# CITY OF ALBUQUERQUE

**Re: HLP Endodontics  
10429 Lagrima Del Oro NE  
Requested for Permanent C. O. – Accepted  
Engineers Stamp Date 6/29/15 (F21D063)  
Certification dated: 6-2-16**

RE: **HLP Endodontics**  
**10429 Lagrima Del Oro NE**  
**Requested for Permanent C. O. – Not Accepted**  
**Engineers Stamp Date 6/29/15 (F21D063)**  
**Certification dated: 6-2-16**

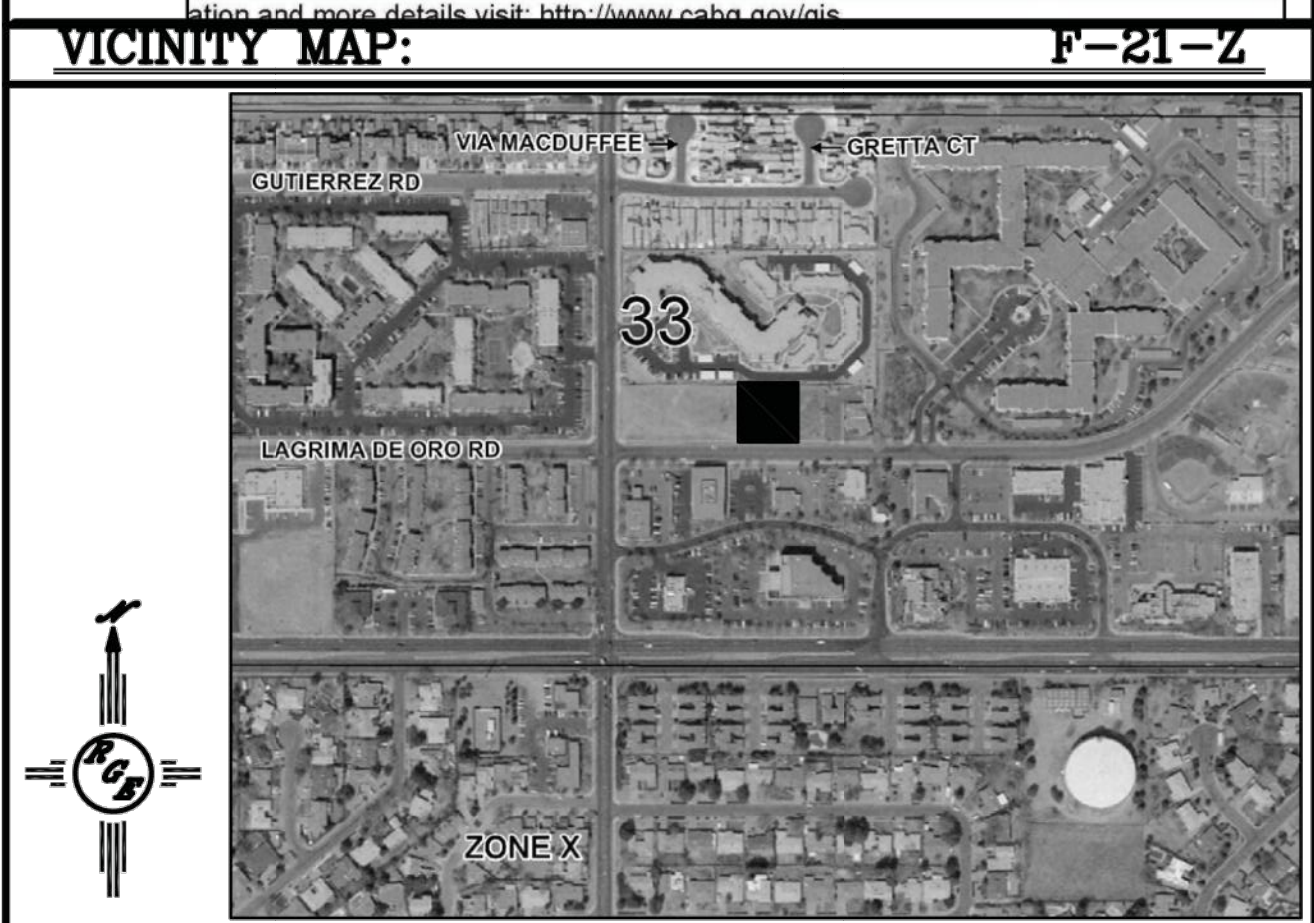
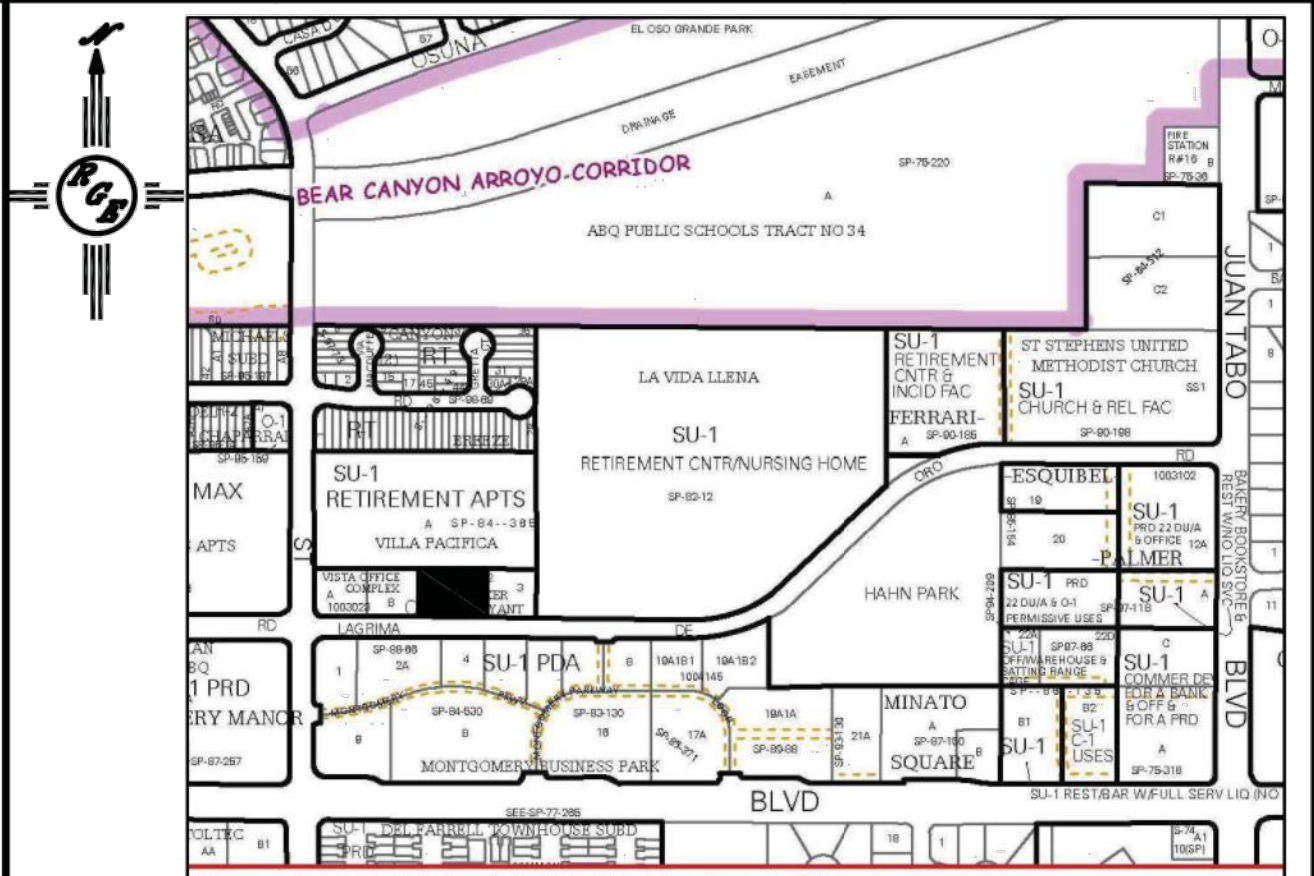
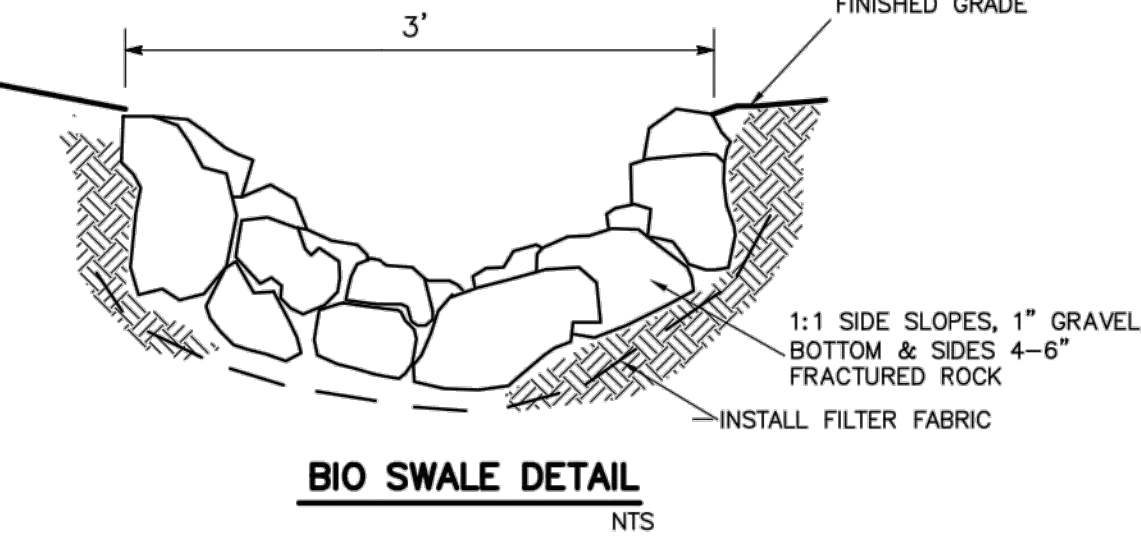
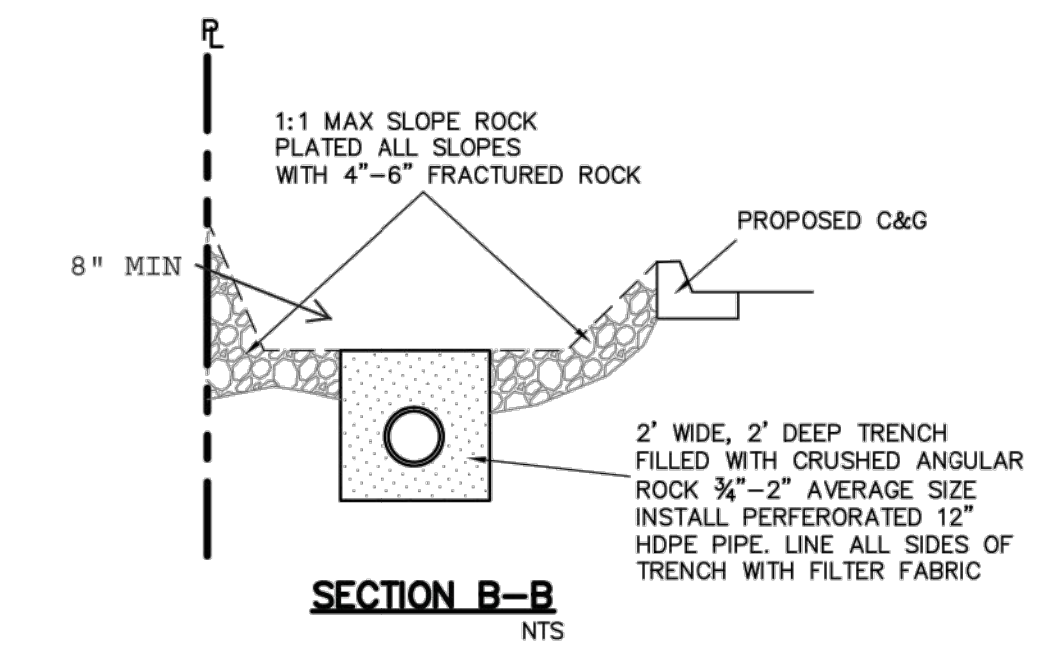
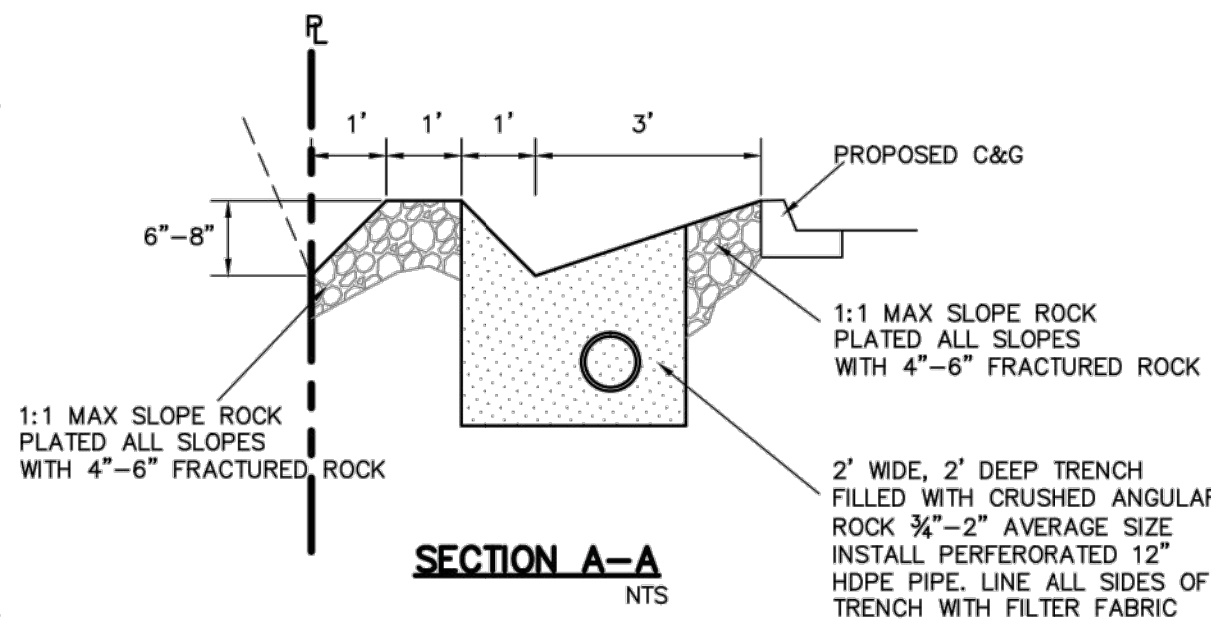
- Ensure that the transformer placed in the middle of the pond does not flood during a rain event. Contact PNM if necessary for recommendations.

- Both 1'-0" curb openings on the north end are missing. **WE OMITTED THE CUTS**
- There is a transformer where the pond at the NE corner was approved. New drainage flows are not as-built on the drawing. **WE CORRECTLY SHOWED POND AND OMITTED CUTS ALLOWS FOR COMPENSATORY FIRST FLUSH VOLUME**
- Only a portion of the rock plated slope w/ retention trench is constructed on the west side. Per the superintendent on site, the portion not constructed is being changed to a retaining wall. This has not been as-built on the drawings. **WE CORRECTLY SHOWED THE WALL**
- The SO-19 sidewalk culvert should be poured monolithic. Culvert should be 2'-0" however it only measures 1'-4". **THE CULVERT WAS REPLACED**
